James A. FitzPatrick  
Nuclear Power Plant  
268 Lake Road  
P.O. Box 41  
Lycoming, New York 13093  
315-342-3840

February 28, 2000  
JAFP-00-0046

Subject: James A. FitzPatrick Nuclear Power Plant  
Docket No. 50-333  
**Core Operating Limits Report**  
**Revision 8 (Reload 13/Cycle 14)**

CORE OPERATING LIMITS REPORT  
REVISION 8

Figure 8.4  
Stability Option 1-D Exclusion Region

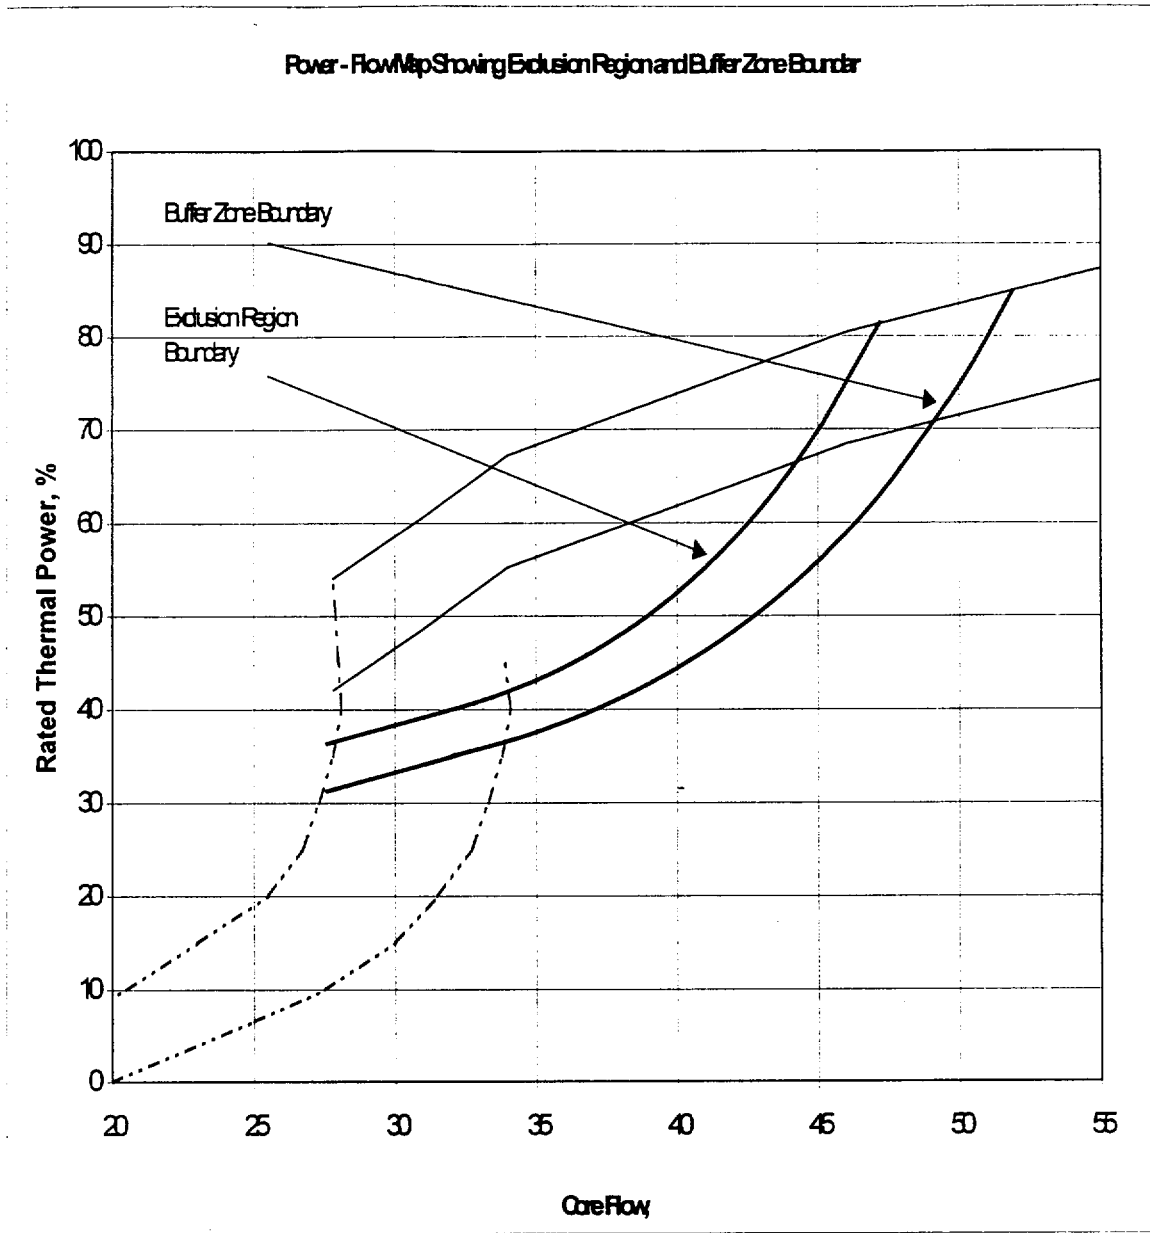
Revision 8 supersedes Revision 7. Revision 8 contains the core operating limits applicable for Cycle 14. This revision changes the exclusion region and buffer zone based on a vendor calculation.

7.6.2 The reactor shall not be intentionally operated within the Exclusion Region given in Figure 8.4 when the SOLOMON Code is operable.

7.6.3 The reactor shall not be intentionally operated within the Buffer Zone given in Figure 8.4 when the SOLOMON Code is inoperable
